"ESF / GROA Interface Drawing Update - FY1995"

B00000000-01717-0200-00124, Rev 00C

Design Analysis Review Summary

Design Analysis Cover Sheet

Figure 7-12

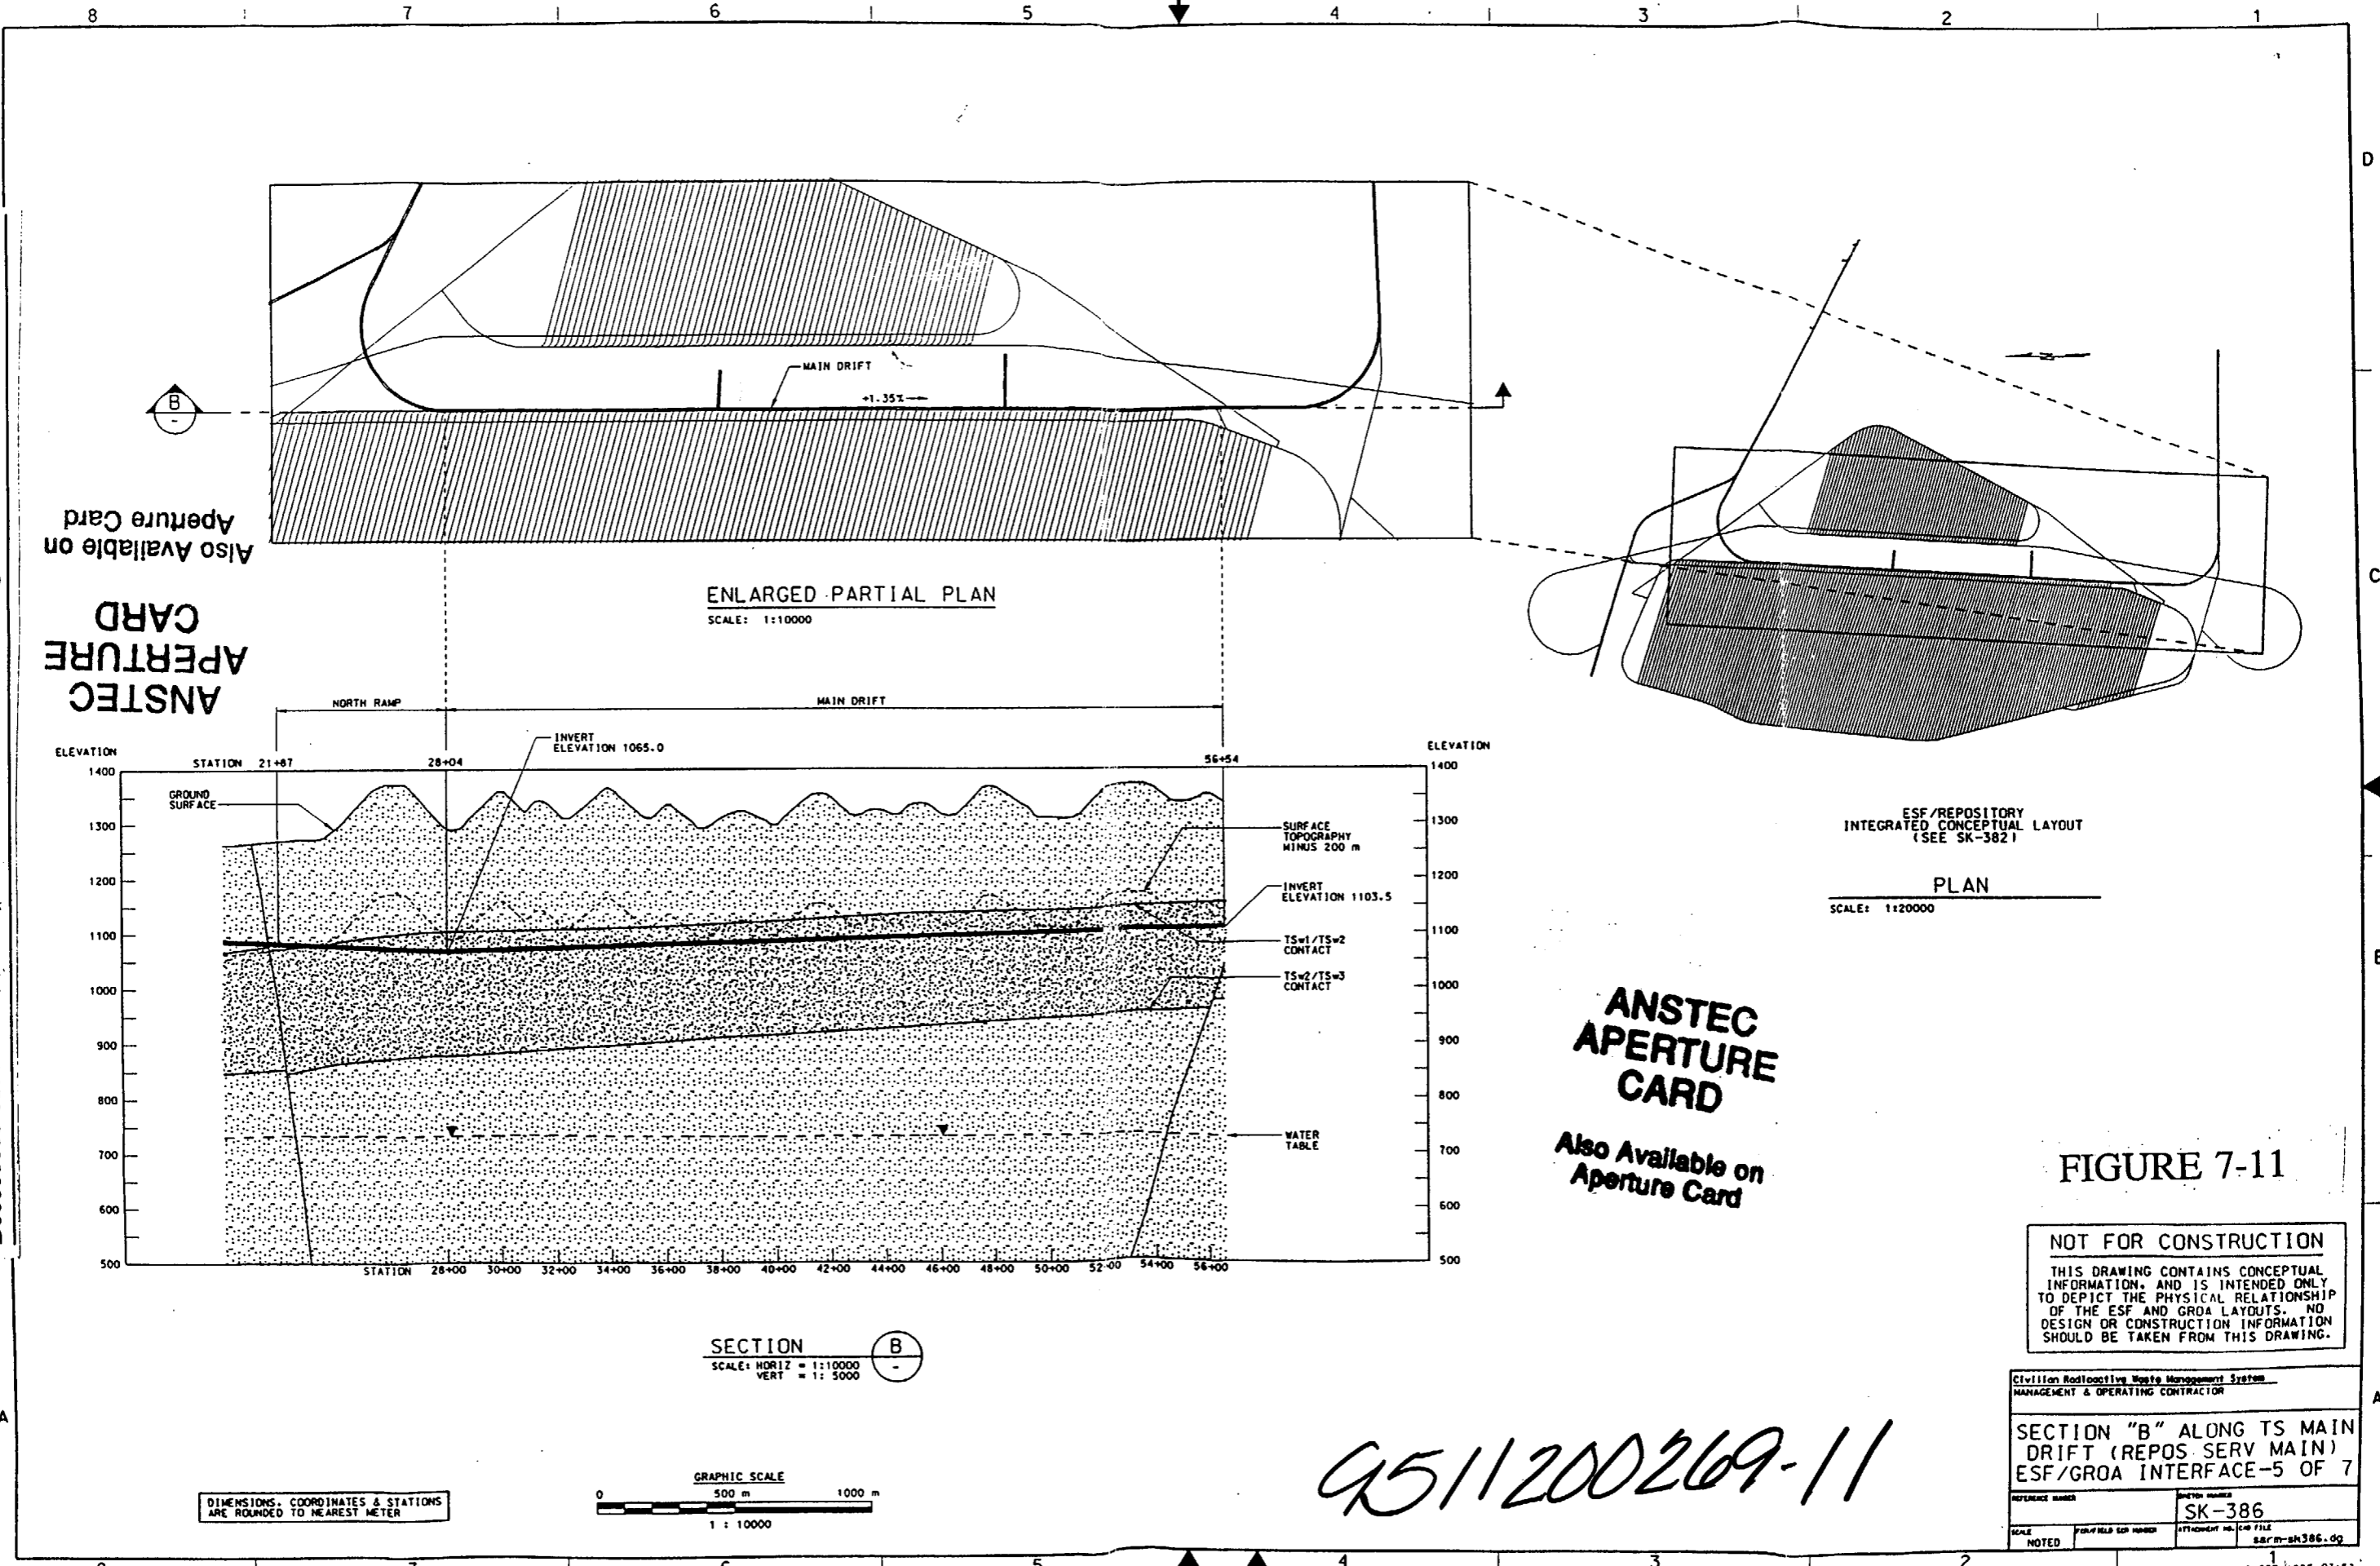
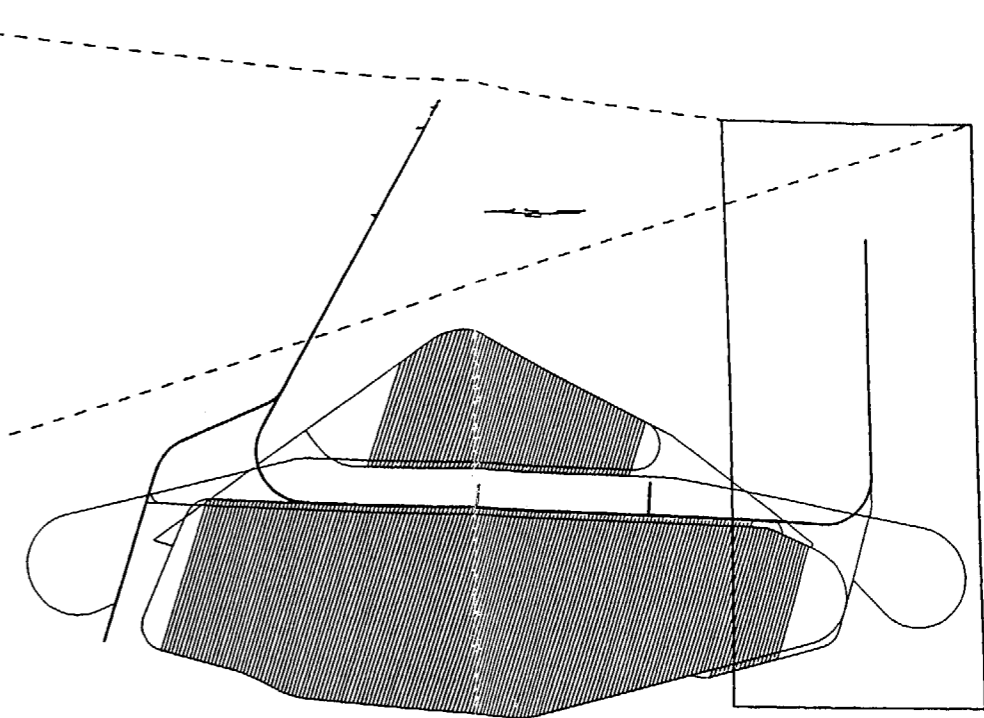
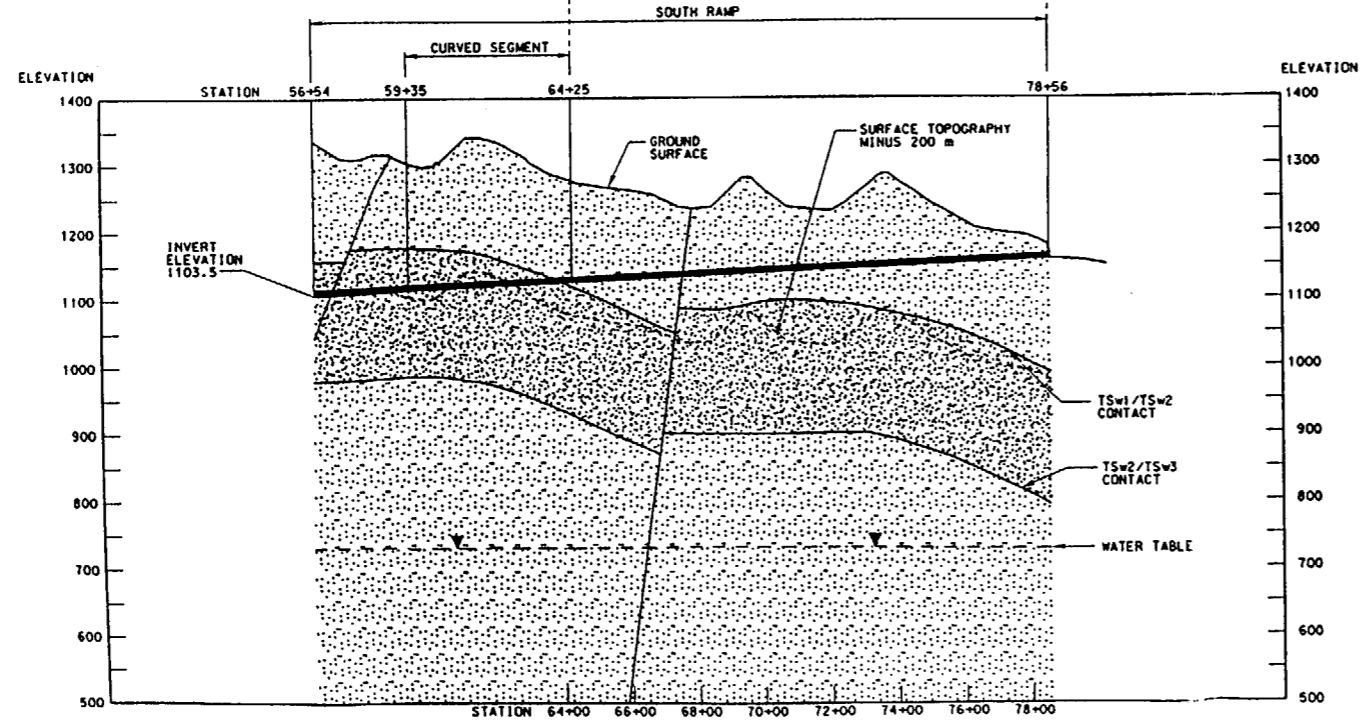
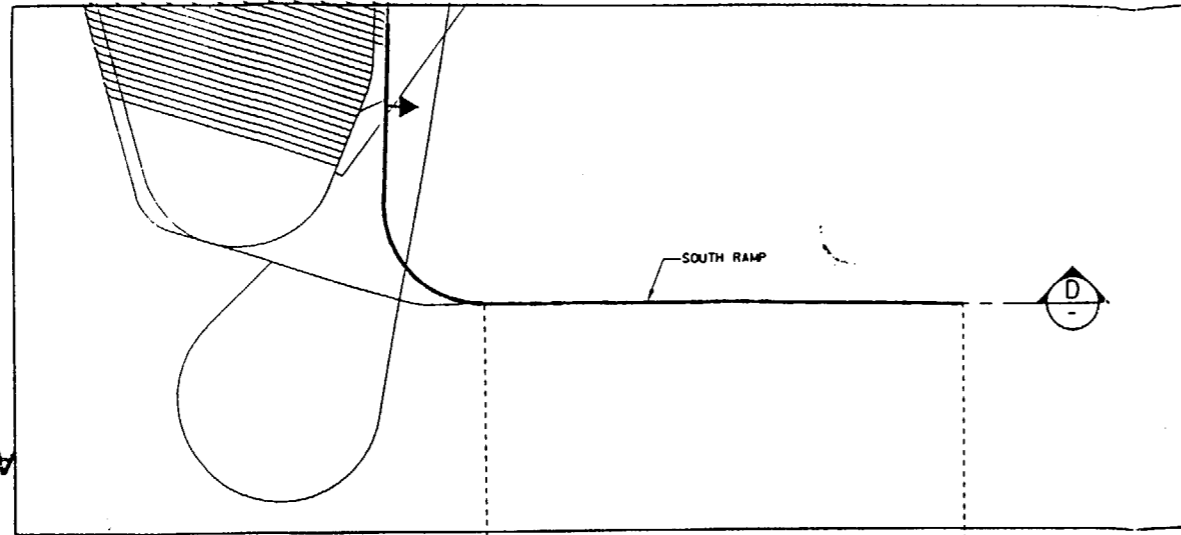
Proposed Change

approximately +1065 meters and at approximately Station 28+04, at a grade of +1.35%. The grade remains unchanged throughout the main drift. The grade changes at the bottom of the south ramp, at about Station 56+54, to +2.57%. See Figures 7-7 and 7-12.

FIGURE 7-13

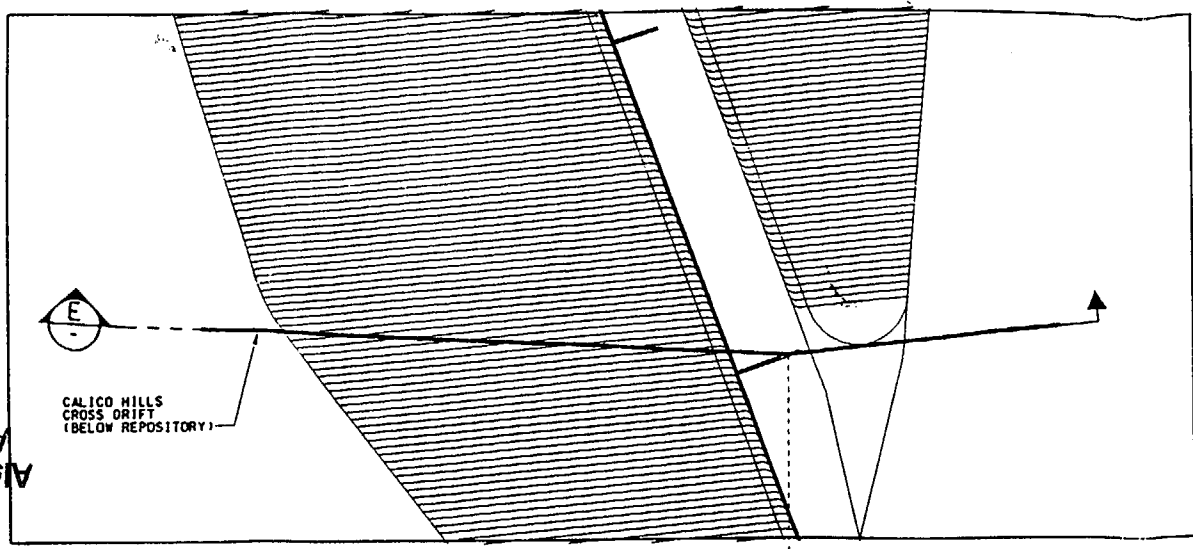
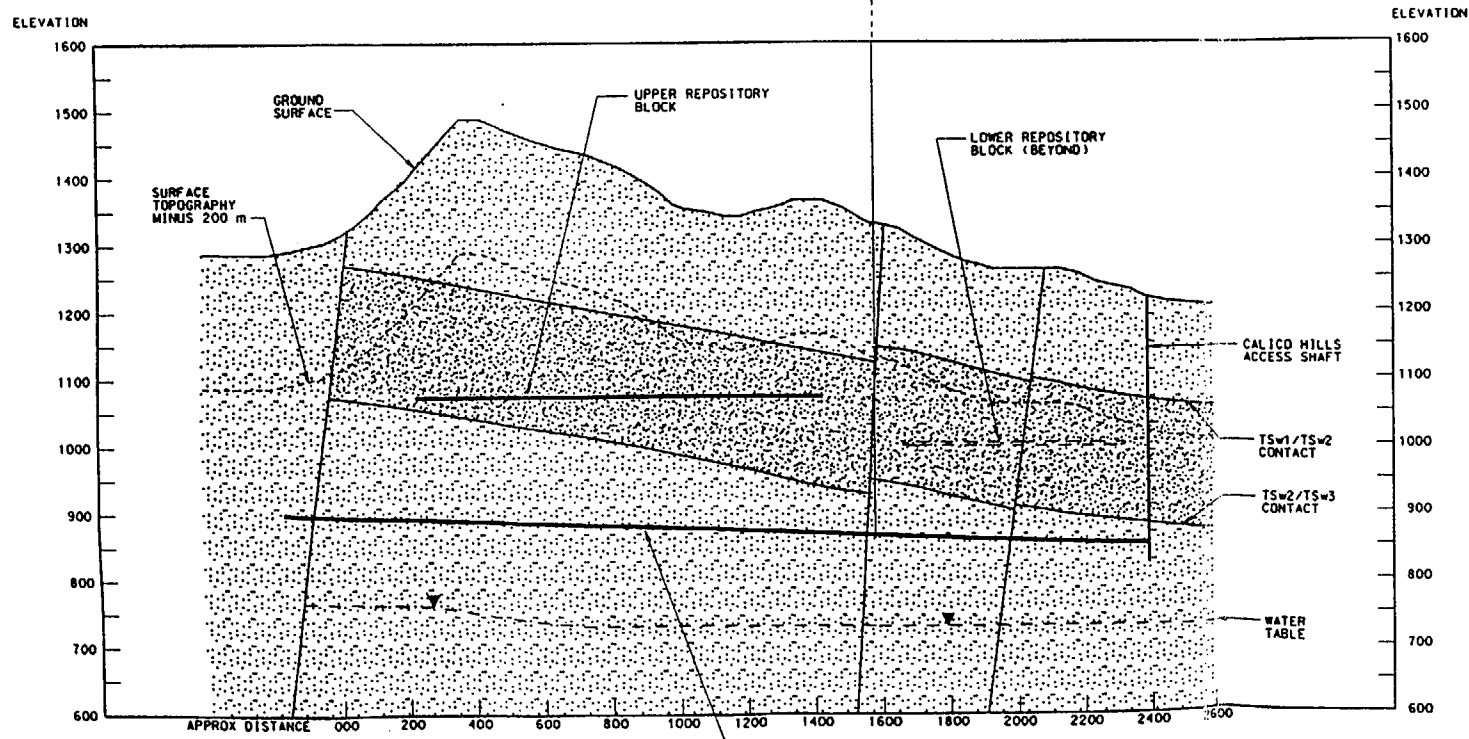
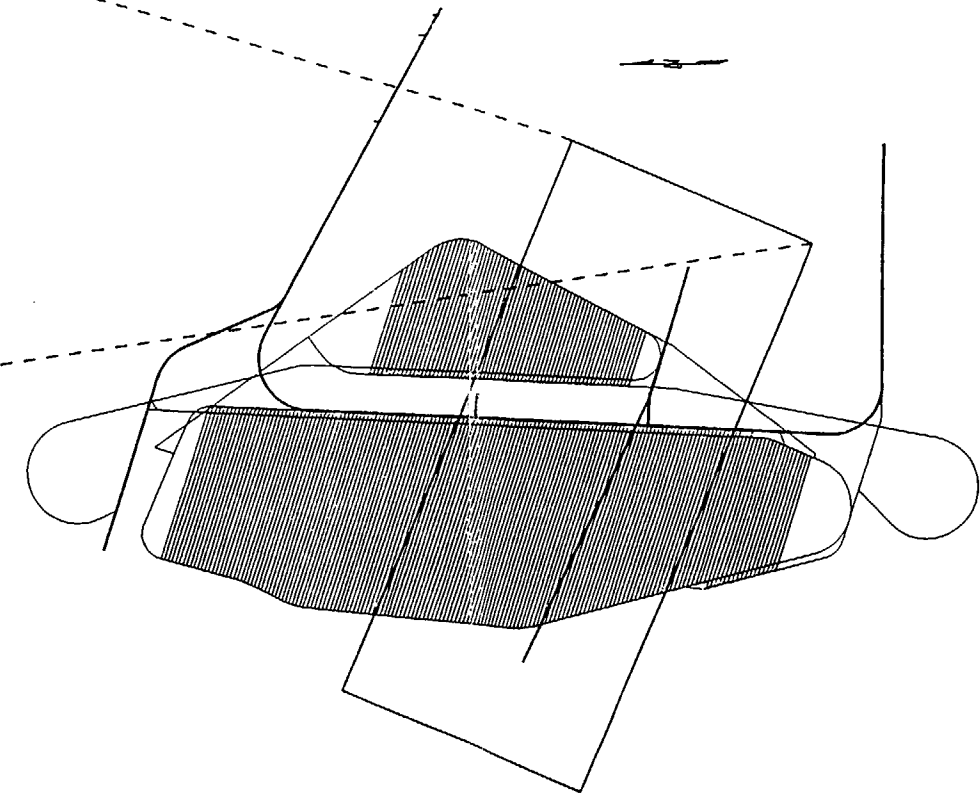
This configuration is shown in plan view on Figure 7-8 and again in cross-section on Figure 7-13. The CH layout consists of a vertical shaft, sited about 450 meters southeast of the repository block near the site of Drillhole UZ-16; and approximately 2,500 meters of drifting to the west from the shaft bottom. The CH Exploratory Drift will pass through the Ghost Dance Fault directly beneath the southernmost Ghost Dance Fault alcove in the upper level and continue to the west to intersect the Solitario Canyon Fault. The drift would end shortly after passing through the Solitario Canyon Fault.
